RE: Lorain County  
Black River Watershed  
New Russia Twp.  
Lorain County Landfill New Main Entrance

**LORAIN COUNTY LANDFILL NEW MAIN ENTRANCE**  
New Russia Twp. Lorain County  
Operator: Republic Services Inc.

**Photos Taken:** October 13, 2010  
**By:** Dan Bogoevski, DSW, NEDO

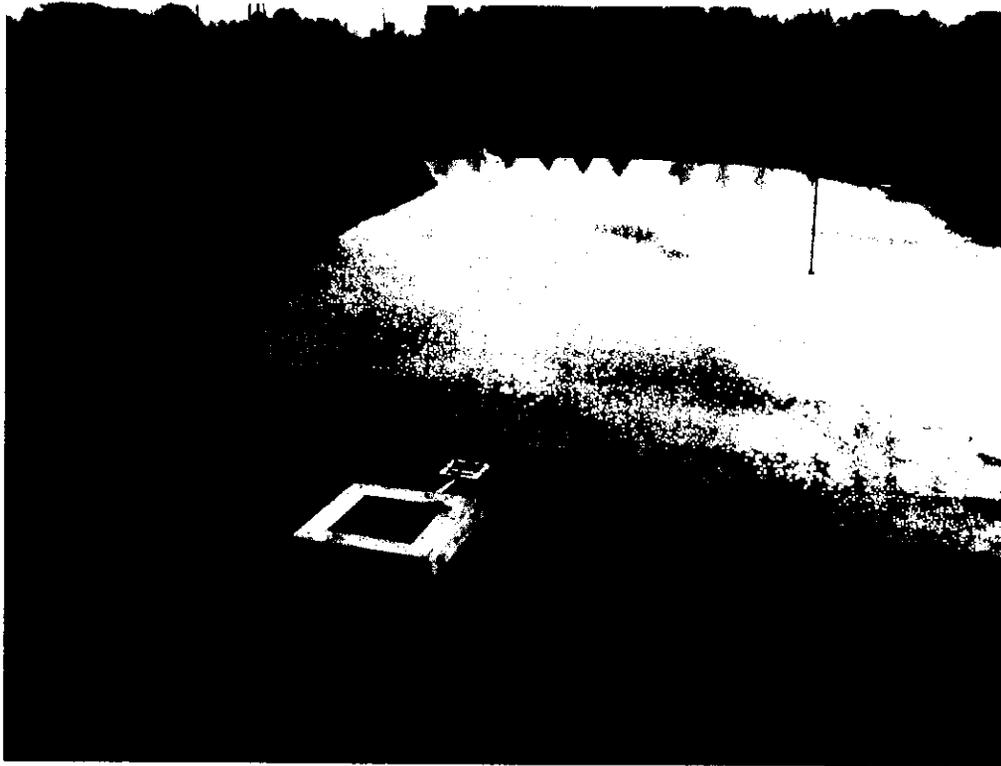
**Fig 1.** The storm water management pond is still configured to be a sediment basin. Some rill erosion is evident on the influent end of the pond.

**Fig 2 & 3.** The holding pond near the truck scales is covered with algae and appears to be leachate impacted. If not managed appropriately, leachate may either enter a catch basin (visible in left photo) or flow over the emergency spillway (visible in right photo).

**Fig 4.** Erosion rill is evident where storm water runoff enters the sediment basin. This must be repaired. Vegetation in the basin must reach a 70% or greater growth density to qualify for final stabilization.

**Fig 5 (LEFT).** No post-construction BMP is installed to control runoff from the Western Roll-Off Storage Area. Runoff flows to the catch basin visible in the foreground of the photo.
